Ford Technical Bulletin

PROCEDURE FOR 2008 F-250/F-550 6.4L DIESEL RADIATOR REPLACEMENT VENTURI TEE INSTALLATION KIT

2008 F-250/F-550 6.4L DIESEL RADIATOR
REPLACEMENT VENTURI TEE

FIGURE 1

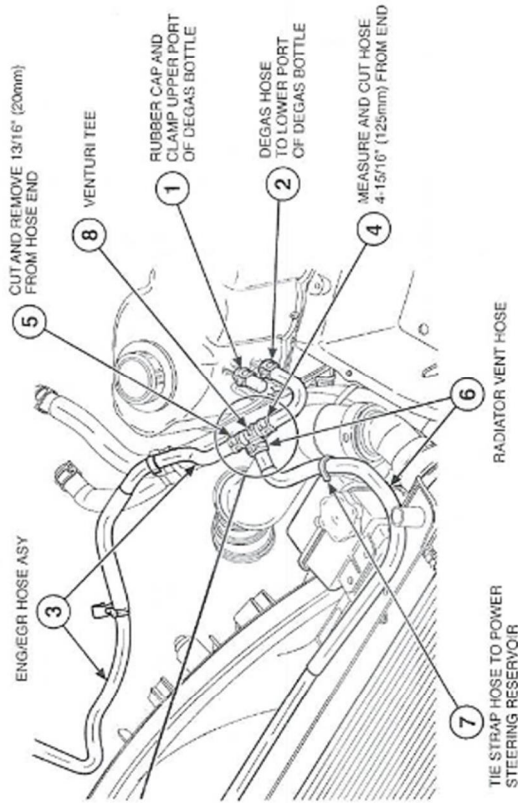
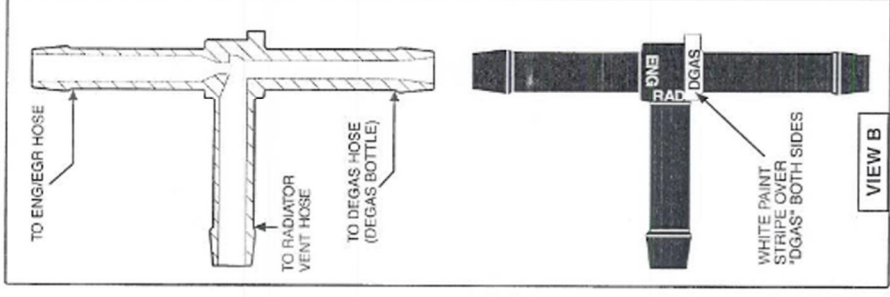
Some 2008 F-250/F-550 Super-Duty vehicles equipped with a 6.4L Diesel engine may exhibit a Radiator coolant leak.

When diagnostics lead to replacement of the Radiator it is necessary to also install the newly released Venturi Tee Service kit. Use the instructions below and illustrations for approved service kit installation and cooling system diagnosis.

1. Remove two (2) vent hoses at Degas Bottle (refer to Figure 1, item 1 and 2).
2. Locate the Exhaust Gas Recirculation (EGA) vent hose (refer to Figure 1, item 3).
3. First cut: Measure and cut hose 125mm from end that attaches to Degas Bottle hose. Include hose bend in measurement (refer to Figure 1, item 4).
4. Second cut: Measure and cut 20mm off opposite end of (EGR) vent hose (refer to Figure 1, item 5).
5. Install two (2) #16 Constant Tension Clamps (CTC) included in service kit on hose ends. Slide new clamps far enough up hoses so they won't interfere with Venturi Tee installation.

NOTE: Installed orientation of Venturi Tee is critical (refer to Figure 1).

6. Insert end of Venturi Tee labeled "ENG" (view B) into Exhaust Gas Recirculation (EGR) vent hose (refer to Figure 1, item 3 and 8).
7. Insert end of Venturi Tee labeled "DGAS" (White Stripe) (view B) into end of Degas hose (refer to Figure 1, item 8).

8. Insert end of Venturi Tee labeled "RAD" (view B) into end of Radiator Vent Hose (refer to Figure 1, item 6 and 8).
9. Install Venturi Tee in a slight upward position to prevent contact with Upper Radiator hose (refer to Figure 1, item 6).

10. Install completed Venturi Tee assembly hose onto lower Degas bottle port (refer to Figure 1, item 2).
11. Verify hoses are not kinked or bent to ensure maximum coolant flow.

12. Tie-strap radiator vent hose to hole in edge of power steering reservoir (refer to Figure 1, item 7).
13. Install rubber cap and clamp assembly (view A) on upper Degas bottle port (refer to Figure 1, item 1).
